ADDENDUM NO. 1

Parks Access Improvements Project C14502318

November 13, 2023

This Addendum No. 1 modifies the Bidding Documents for the Parks Access Improvements Project C14502318. This Addendum shall become part of the Contract and all provisions of the Contract shall apply thereto. Bidders shall acknowledge all Addendums in the Bid Schedule.

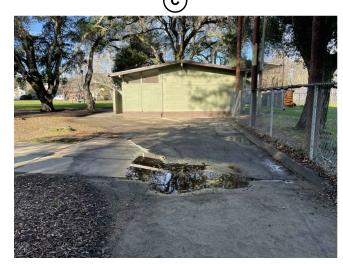
- 1. **Replace** Sheet C3 with the sheet included in this Addendum No. 1 package.
 - a. The changes to the sheet include revising the footprint of the new concrete pathway, which has extended and increased from 2,400 SF to 2,600 SF.
